Knocking Noise from Rear Brake when Braking

Applicability

YEAR(S)	MODEL(S)	ADDITIONAL INFORMATION
2022 - 2024	NX350H	
2022 - 2024	NX450H+

Some 2022 – 2024 model year NX 350h and NX 450h+ vehicles may exhibit a knocking from one or both rear brakes due to delamination of the rear disc brake pad material from the base plate. Improved parts have been made available. Please follow the Repair Procedure in this bulletin to address this condition.

Figure 2.

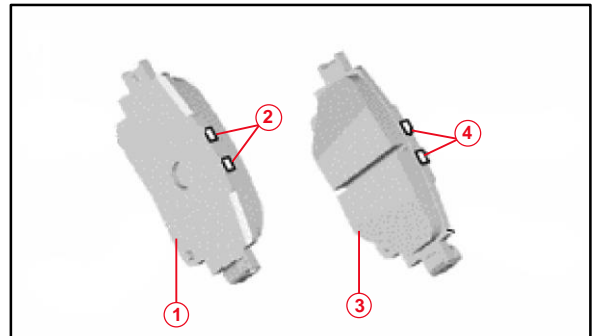
The newly designed inner pad has two pink marks. The newly designed outer has two light-blue marks. See Figure 2.

1	Outer Side
2	Light Blue Marks
3	Inner Side
4	Pink Marks
